TECHNICAL BULLETIN

[Issue No.] FA-A-0046

[Title] Precautions for using a dummy CompactFlash card in the C Controller moudule

[Relevant Models] Q06CCPU-V, Q06CCPU-V-H01

Figure 1 Serial No. display (For the Q06CCPU-V)

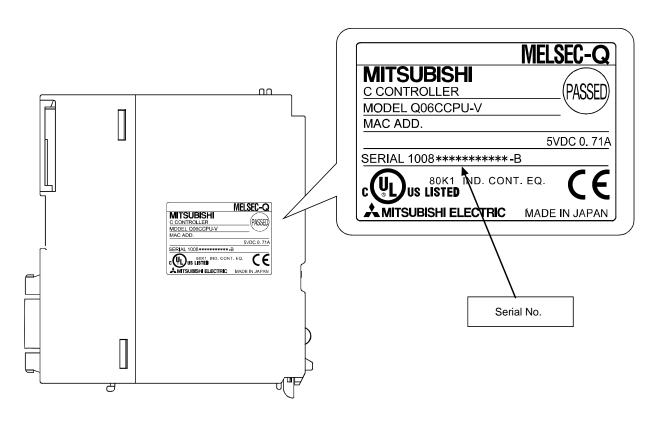
When installing a dummy CompactFlash card to the C Controller module, use the dummy CompactFlash card installed when shipping. Do not use any dummy CompactFlash card that has no "A" shown in the Figure 2 in the products whose serial number (first four digits) is "1008" or later as shown in the Figure 1. Failure to do so may disable the removal of the dummy CompactFlash card, resulting in damage to the CompactFlash card slot.

A dummy CompactFlash card with "A" shown in Figure 3 printed is installed to the products whose serial number (first four digits) is "1008" or later when shipping.
